**MOIESE MEADOWS (LORDS)  
33-LOT MAJOR SUBDIVISION**

**STAFF REPORT FOR PLANNING BOARD**

### MOIESE MEADOWS 33-LOT MAJOR SUBDIVISION

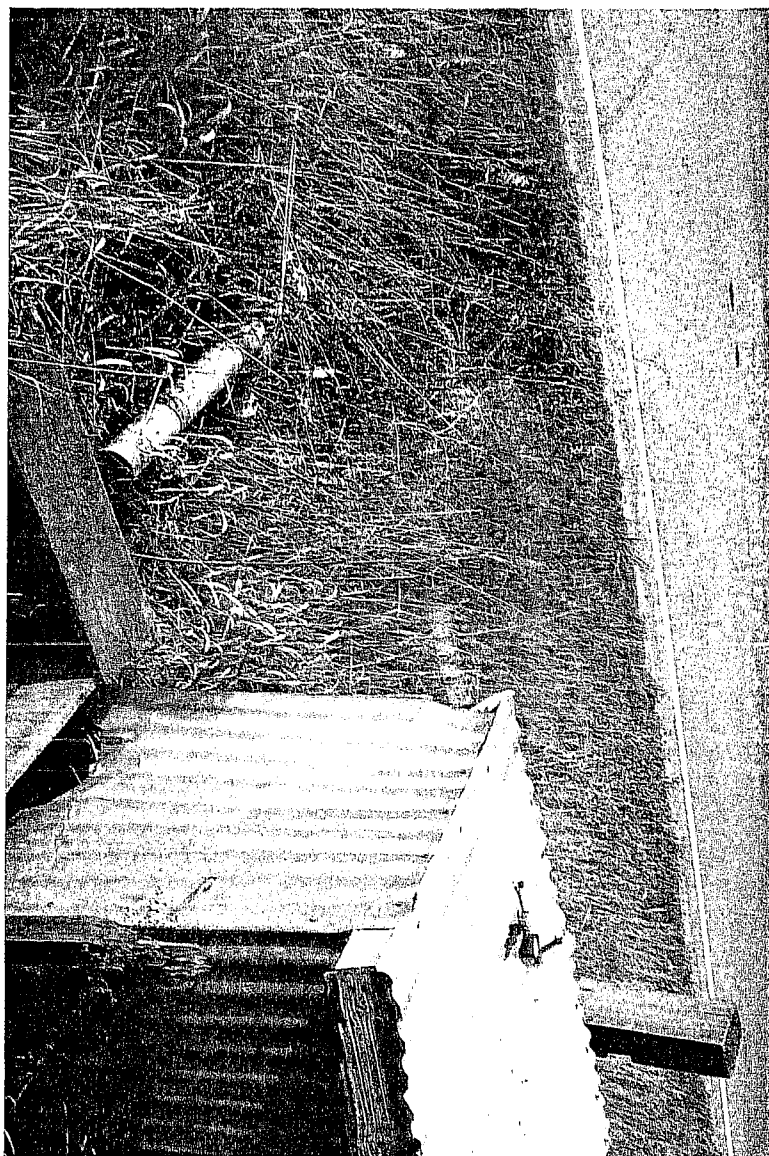
pipe  
needs  
to ASSE to  
get proper  
water flow.  
requesting 12" pipe.

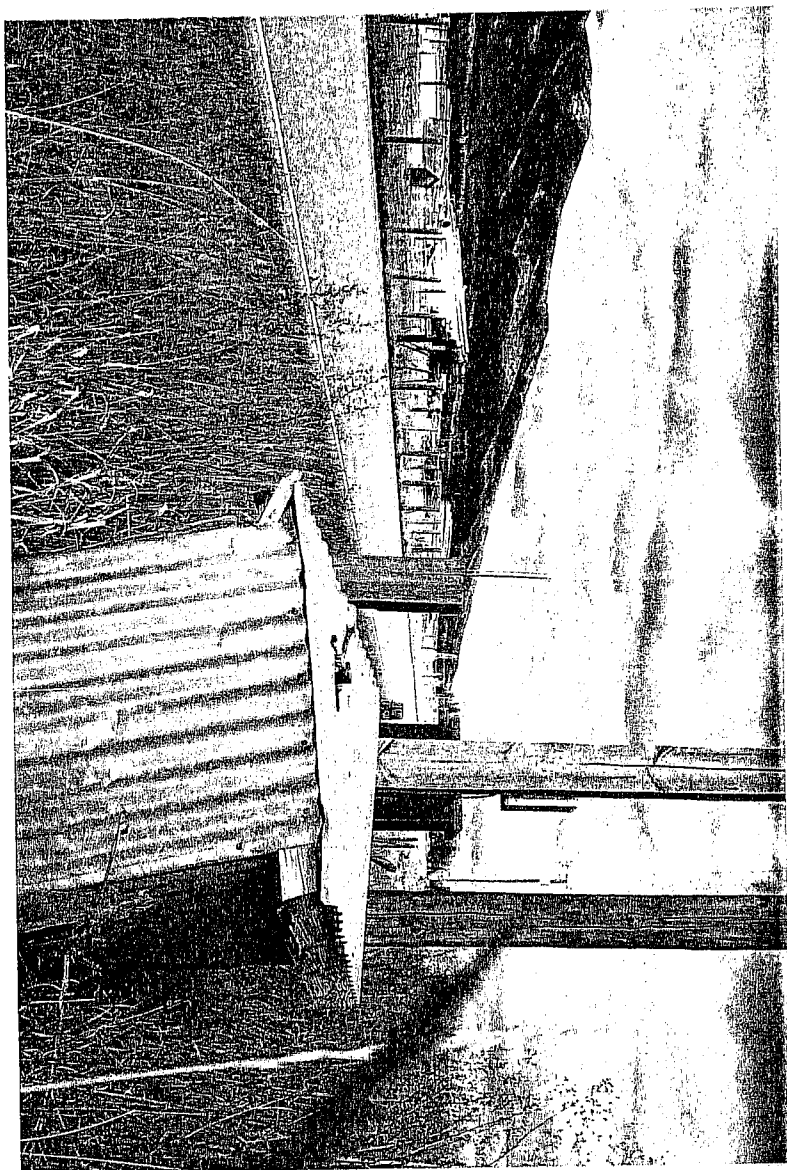
proposed 24" pipe

pipe that  
goes under Hwy to F/H  
property

current  
pump house -  
established irrigation  
site.

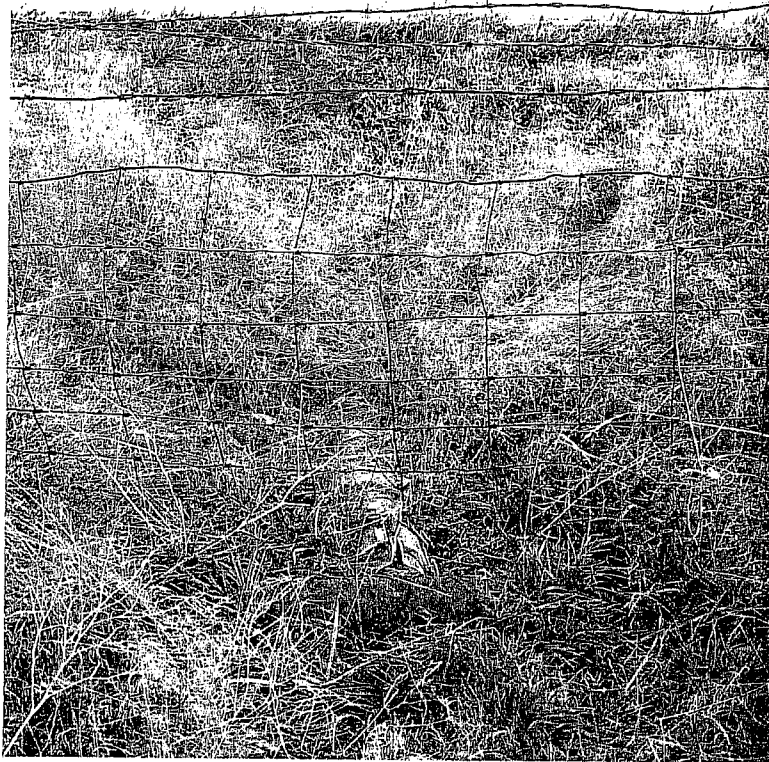
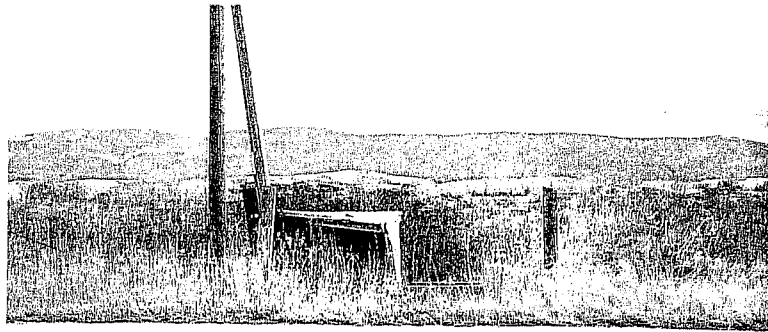
Looking across from F/H property to  
established irrigation access site - telephone  
pole probably poses a visibility problem  
also - entering & exiting proposed subdivision

↑  
current access site

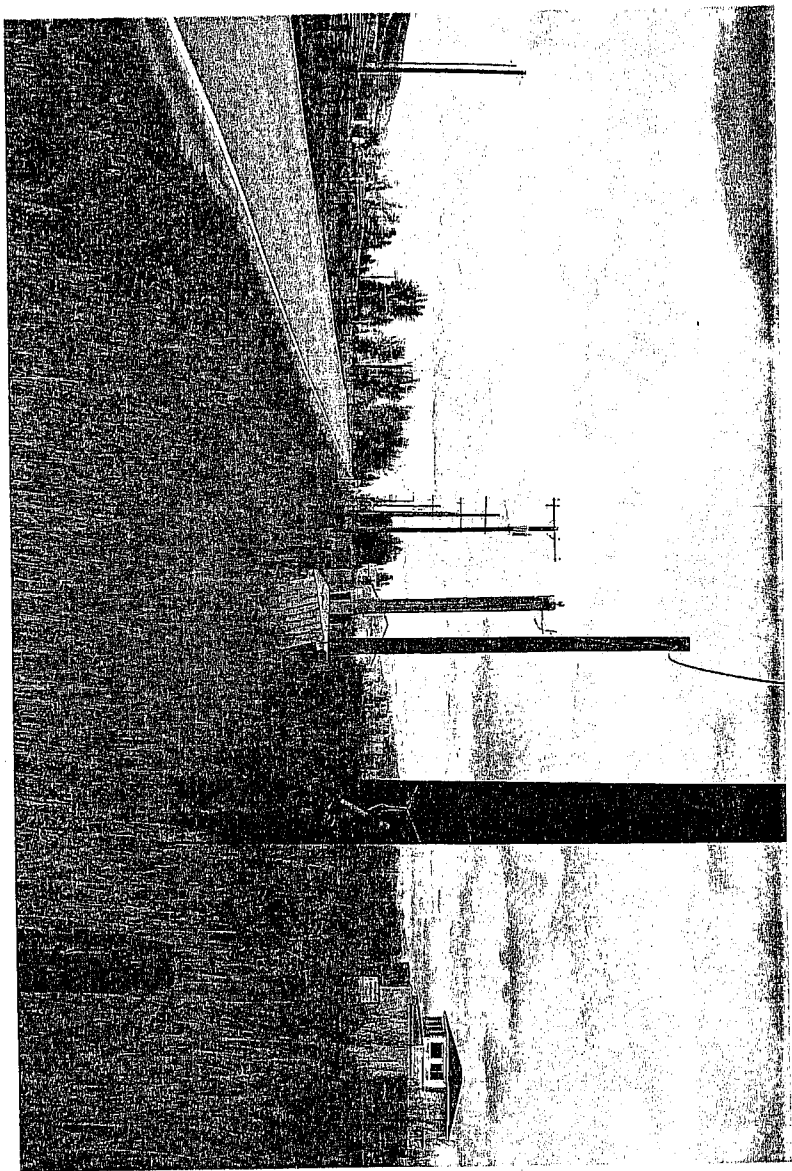
pump  
house +  
poles

telephone  
pole
